Subject: Reported Contamination at Milwaukee Die Casting Company, Inc.  
4132 N. Holton Street, Milwaukee, WI  
BRRTS Activity # 02-41-000023, FID # 241228240

The purpose of this letter is to notify Pharmacia and Fisher, the Responsible Parties (RPs), that additional environmental investigation and remediation of contamination at the Milwaukee Die Casting Company (MDCC) site are required for compliance with the hazardous substance spill law, Wis. Stat. § 292.11(3). An assessment of potential contamination above state regulatory standards in all environmental media is needed to determine the remedial actions necessary to restore the environment. Efforts to date, have focused primarily on investigation and removal of polychlorinated biphenyls (PCBs) and shallow chlorinated solvents contamination in soil. Limited groundwater investigation has been conducted, but remains incomplete.

Attachments: Figure B.3.b. – Groundwater Iso-Concentration Map [Pre-Soil Removal Action]  
Table A.1 – Groundwater Analytical Table [Pre-Soil Removal Action]

Drawing No. 12 – Extent of VOCs in Surface Soils  
Drawing No. 13 – Extent of VOCs in Deep Soils  
Figure 3-7 – Potentiometric Surface Map Septembe

FIGURE  
**3-7**

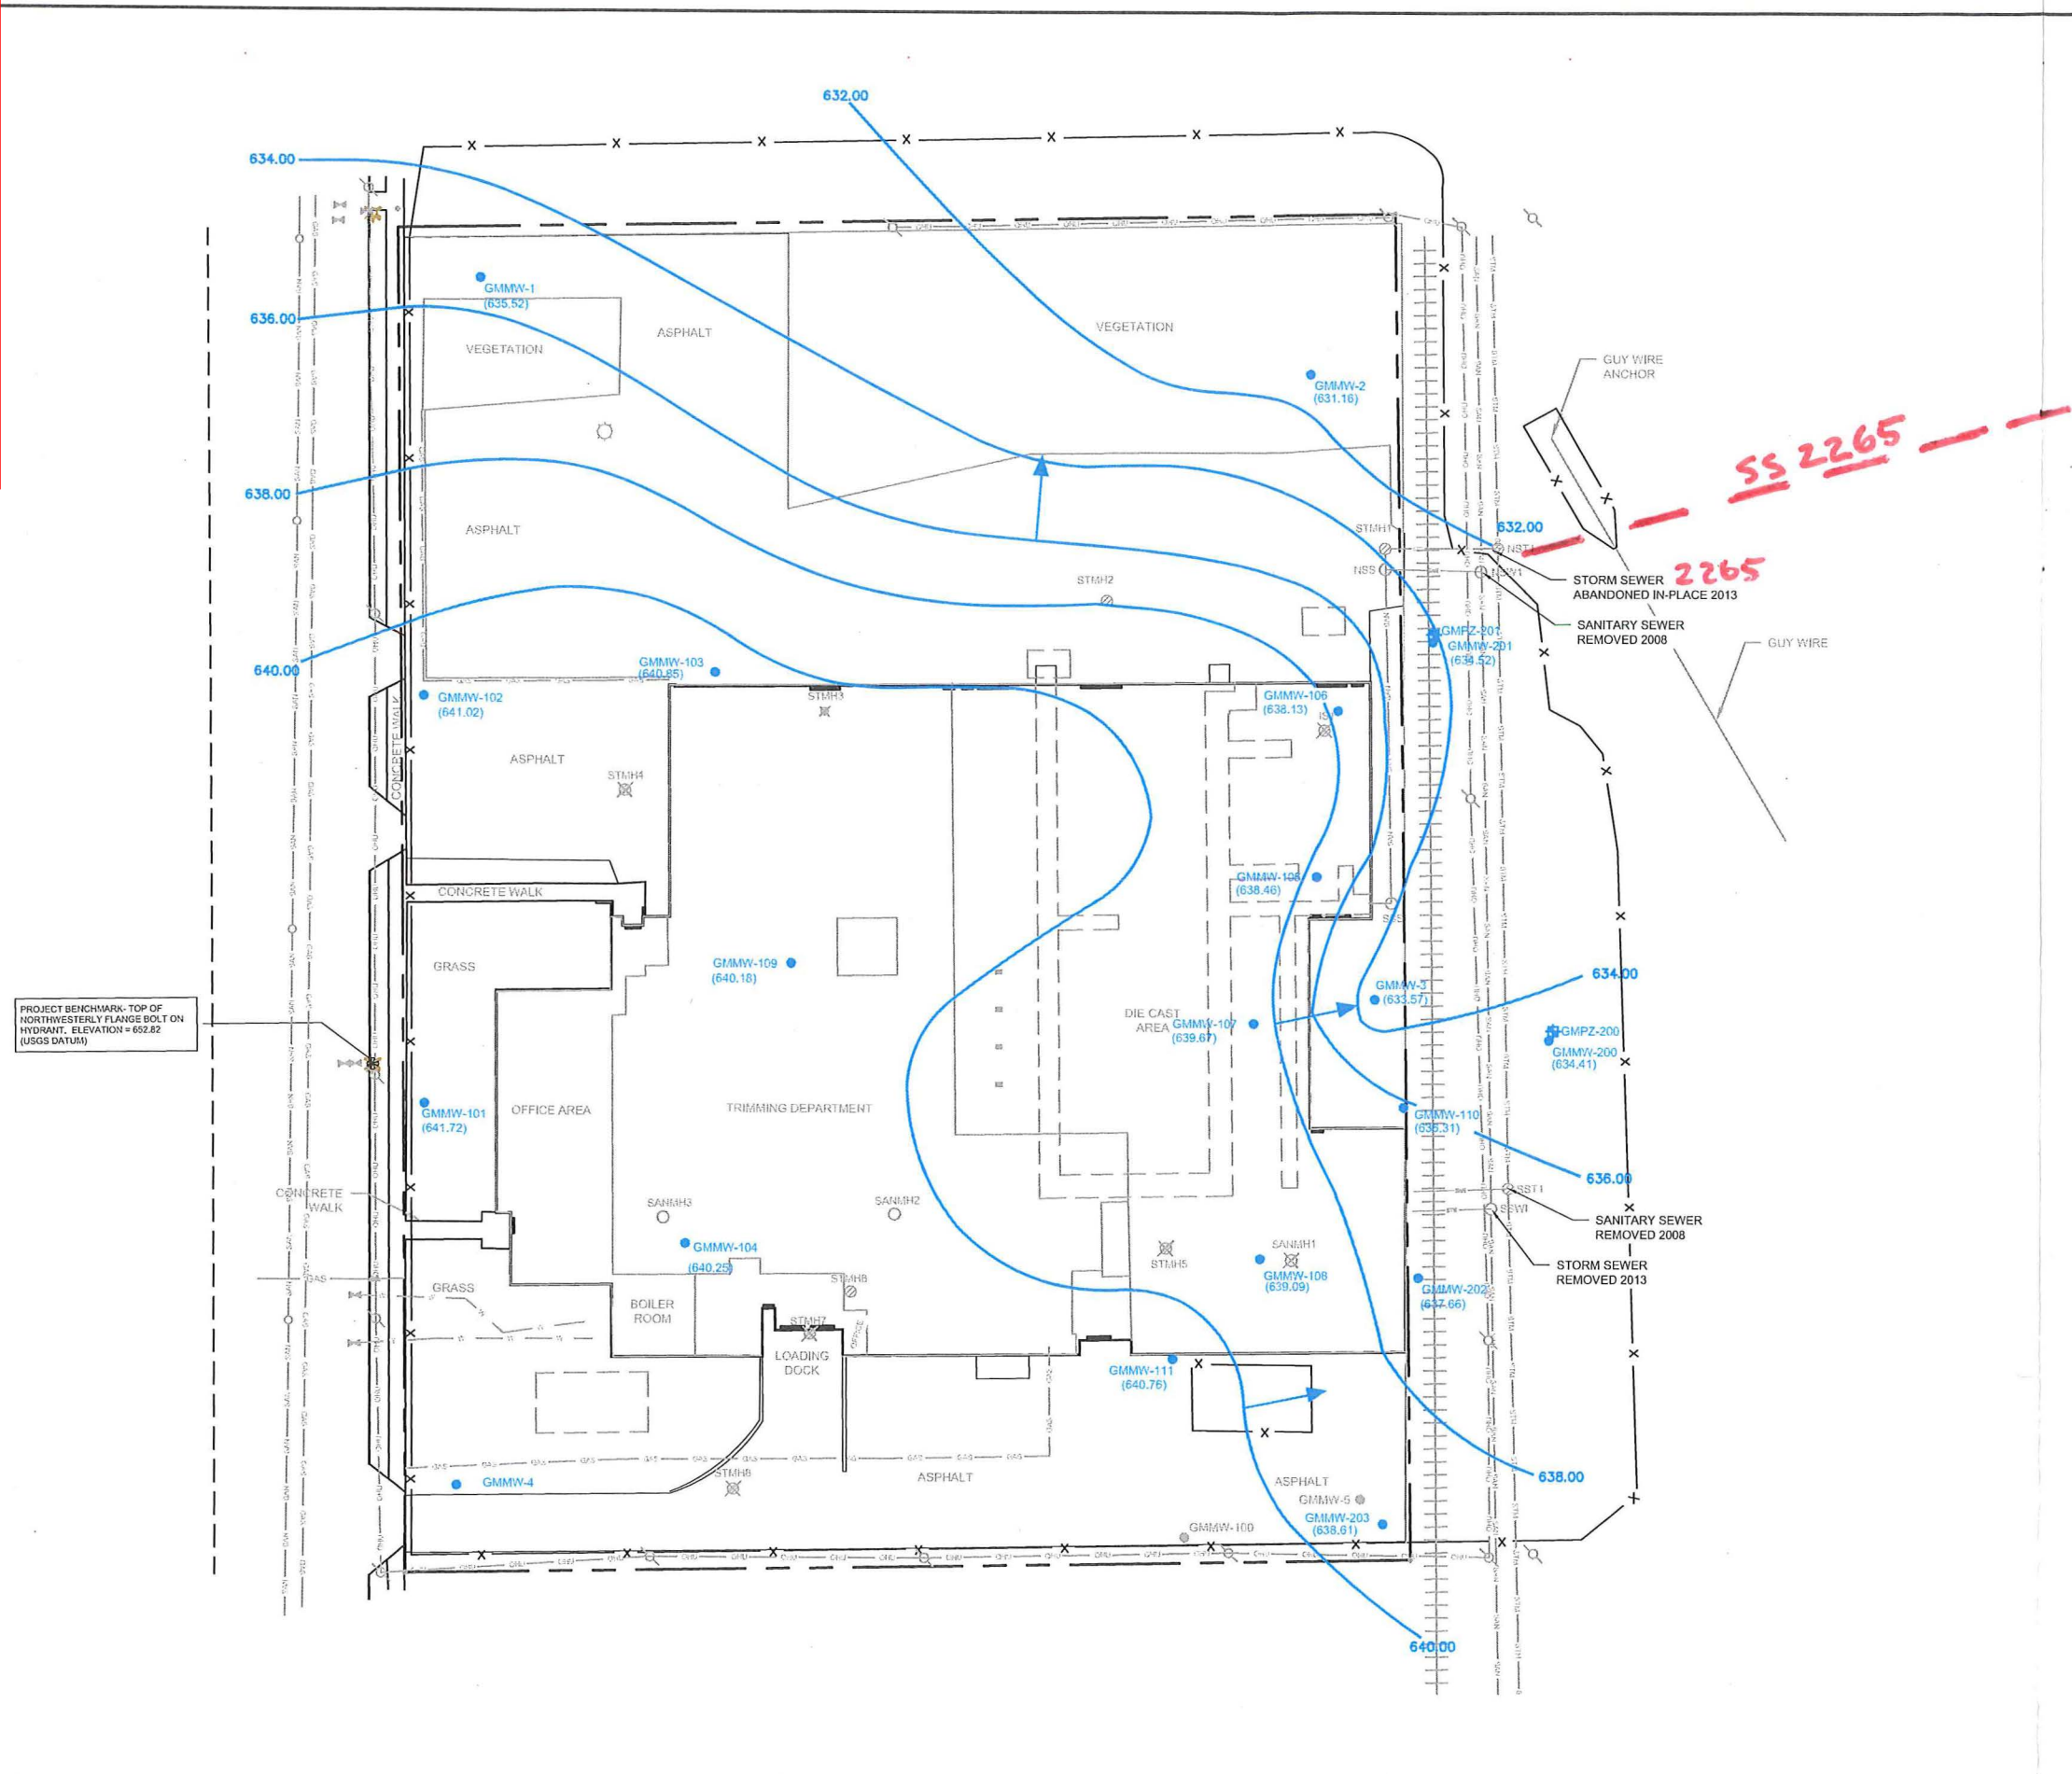
- The storm and sanitary sewer line trenches immediately to the east (downgradient) of the former MDCC facility property. The trenches may intercept and direct groundwater plume migration to the north, south, and/or northeast towards the storm sewer outfall to the Milwaukee River. Figure 3-7 Potentiometric Surface Map appears to reflect this situation by the abrupt decrease in CVOC concentrations from former monitoring wells GMMW-110 and GMMW-202 (west side of sewers) to GMMW-200 (east side of sewers). See previously mentioned Figure B.3.b.

Location of the Storm Sewer System  
in Milwaukee River outfall.
